**CA07018 Revision 0, Main Feedwater Pressure Input Uncertainty to the  
Caldon CheckPlus LEFM**

**MAIN FEEDWATER PRESSURE INPUT UNCERTAINTY TO CALDON  
CHECKPLUS LEFM**

**For Calvert Cliffs Nuclear Power Plant  
Units 1 & 2**

**RESPONSE TO REQUEST FOR ADDITIONAL INFORMATION  
DATED NOVEMBER 17, 2008- MEASUREMENT UNCERTAINTY  
RECAPTURE POWER UPRATE**

Figure 1: Unit 1 Caldon LEFM CheckPlus Spool Piece Locations

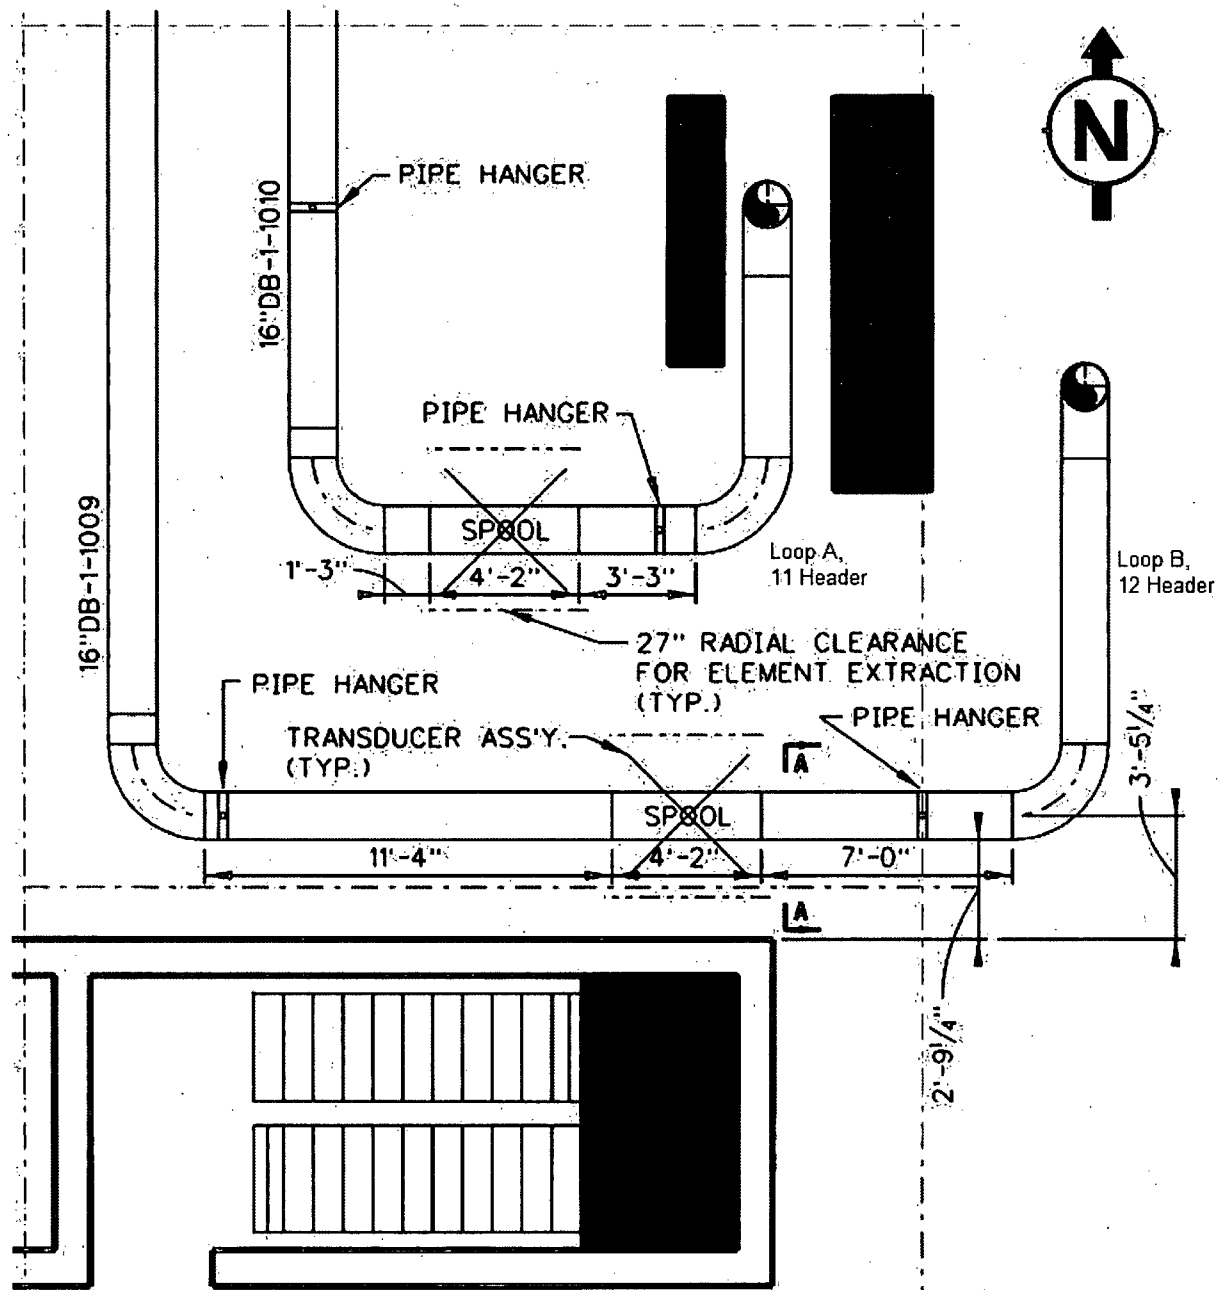
*Describe and provide drawings of the location where the ultrasonic flow meters will be installed in the 16" feedwater header for each steam generator.*

For 11 Feedwater Header (Loop A of Figure 1), the feedwater piping drops approximately 5'4" below the feedwater regulating valve, then turns south for approximately 9' before turning to the west. The flowmeter is located in the East-West pipe run, approximately 3'3" from the exit of the 90 degree elbow located upstream of the spool piece.

For 12 Feedwater Header (Loop B of Figure 1), the feedwater piping drops approximately 5'4" below the feedwater regulating valve, then turns south for approximately 12' before turning to the west. The flowmeter is located in the East-West pipe run, approximately 7' from the exit of the 90 degree elbow located upstream of the spool piece.
